STAFF REPORT
(Preliminary Plat)

CASE NUMBER: S/D 94-24 FELLOWSHIP ACRES ADDITION
OWNER/APPLICANT: Rolling Hills Baptist Church, 13600 W. Kellogg, Wichita, KS 67235
AGENT: Roy Dodd, 9210 Hickory, Wichita, KS 67212
SURVEYOR/ENGINEER: Howard A. Rishel, 101 N. Main, Haysville, KS 67060
TOWNSHIP: Don Lessenden, Trustee, Attica Township, 1143 S. 199th St. West, Goddard, KS 67052
STATE: Mr. Wade Culwell, District #5 Representative, Kansas Dept. of Transportation, 500 N. Hendricks, P. O. Box 769, Hutchinson, KS 67504-0769
LOCATION: Northwest corner of U.S. Highway 54 and 135th Street West
SITE SIZE: 9.66 Acres
NUMBER OF LOTS
Residential:
Office:
Commercial: 1
Industrial:
Total: 1
MINIMUM LOT AREA: 9.66 Acres
CURRENT ZONING: "C" County

(Final Plat, Preliminary Plat Approved April 28, 1994)

VICINITY MAP:

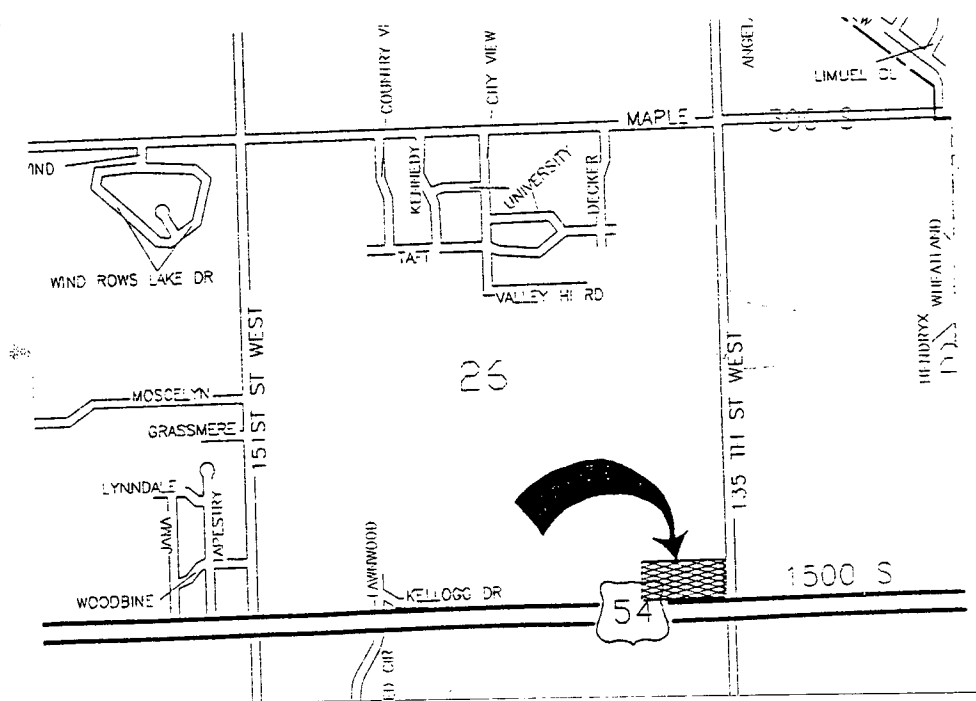
- A. City and/or County Engineering need to indicate any requirements as to the present or future extension of sanitary sewer and water to this site. This site is near Wichita's City limits but no municipal services appear to be reasonably close to the site.

- B. Since neither municipal water nor sanitary sewer is available to serve this property, the applicant shall contact the Environmental Health Division of the Health Department to find out what tests may be necessary and what standards are to be met for approval of on-site sewerage facilities and water wells. A memorandum shall be obtained specifying approval.

- C. Major developments have been occurring or are planned adjacent to 135th Street West north of this site. Also, 135th Street West will be the means of access to this development, however, 135th Street West is unpaved at this location. City and/or County Engineering need to indicate requirements for guaranteeing the paving of 135th Street West.

- D. City and/or County Engineering also need to indicate if the right-of-way for U.S. 54 shown by the plat is adequate and if a frontage road is to be provided, does plat need to guarantee the paving of such a frontage road.

- F. Since 135th Street West is a mile line, arterial road adjacent to this site, the final plat shall dedicate the required major intersection right-of-way for this street. That is, 75-feet of half street right-of-way for a distance of 250-feet from the center line of U. S. 54, then tapering to 50-feet for the next 100-feet.

- G. In terms of access controls, "Complete Access Control" shall be shown from the south 100 feet of the Addition to 135th Street West with two openings allowed for the remaining frontage to 135th Street West. As for U.S. 54, the final plat shall either indicate the access controls provided for by the Condemnation Case or if a frontage road is involved, that access control, complete or otherwise, exists between U.S. 54 and such Frontage Road.

The plat's text shall also note the dedication of access controls, noting that the dedication is to the appropriate governing body with the location of any allowed openings to be approve by the appropriate engineer.
- H. The applicant is advised that this site is within 3-miles of Wichita and the final plat shall include signature blocks for both the City of Wichita's and the County Commission's approvals.
- I. Requirements for a final plat (see pages 5-5 through 5-10, Part 4, Article 5 of the MAPC Subdivision Regulations).
- J. Prior to or at the time of submitting the final plat, the applicant shall submit a drainage plan to County Engineering for review and approval.

VICINITY MAP:

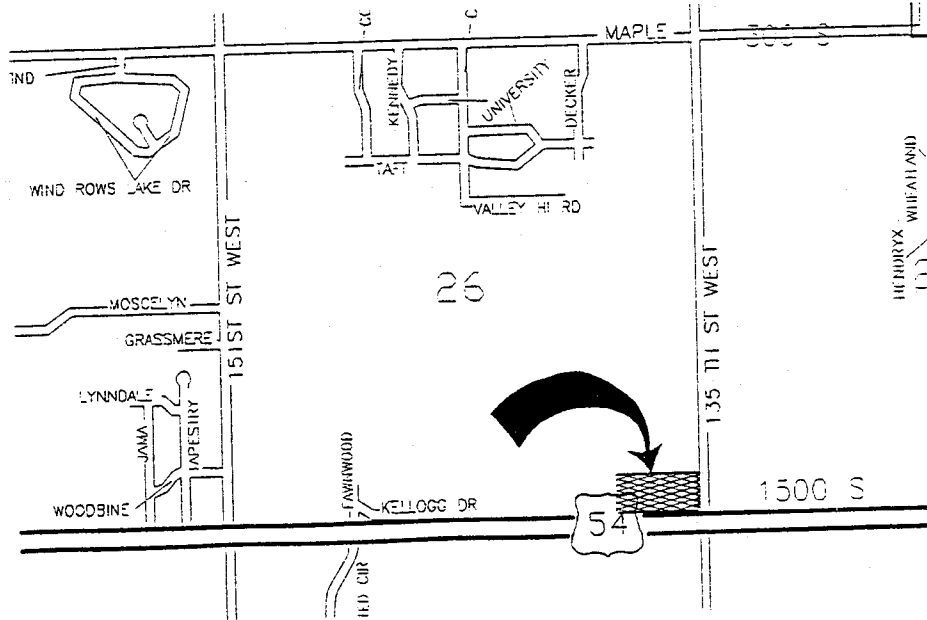
- A. The applicant shall submit a petition to guarantee the extension of Wichita water across this Addition's frontage on 135th Street West. This petition will be held for the future extension of such water.

- B. Since neither municipal water nor sanitary sewer is available to serve this property, the applicant shall contact the Environmental Health Division of the Health Department to find out what tests may be necessary and what standards are to be met for approval of on-site sewerage facilities and water wells. A memorandum shall be obtained specifying approval. The Health Department needs to comment on the status of these tests.

- C. The applicant shall attempt to obtain a valid paving petition for 135th Street West adjacent to this site. If such a petition cannot be provided, the applicant is advised to meet with City Engineering to discuss if this site could be included within other petitions being proposed for 135th Street between Maple and U.S. 54. If a valid petition cannot be provided or this site included in another petition, the applicants shall submit an affidavit indicating their willingness to participate in any future paving guarantees (petitions) for this street.

- D. The representative from County Engineering shall be prepared to comment on the need to obtain a guarantee for the paving of the frontage road and, if a guarantee is necessary, what width of paving is required.

- E. The name of the frontage road shall be designated on the face of the plat. The recommended name is Harry Drive.
- F. If improvements are guaranteed by petition, a notarized certificate listing the petitions shall be submitted to the Planning Department for recording.

- I. Numerous corrections need to be made on the final plat tracing before this plat can be forwarded to the governing bodies for review. One of the major corrections needed is the legal description in the surveyor's certificate. The legal given on this final plat submitted for Subdivision Committee review is for Lot 1 only, without any street right-of-way being included. That would indicate that all of the right-of-way shown for 135th Street and for the frontage road already exists, yet the plattor's text refers to the dedication of streets. The legal description must include all right-of-way now in this applicant's ownership which is being dedicated by this plat for streets as well as all land being platted into a lot.

The plattor's text shall dedicate the access controls depicted on the face of the plat, noting that the dedication is to the appropriate governing body with the location of any allowed openings to be approved by the appropriate engineer.

The signature block for Wichita City Council approval shall be included since this site is within 3 miles of the Wichita city limits.

- J. Item 8 of the platting binder references an easement granted to KG&E in 1936. The applicant or agent shall review this document and if the easement affects Lot 1, it shall be shown on the face of the plat. A copy of the recorded easement shall be submitted to the Planning Department.
-
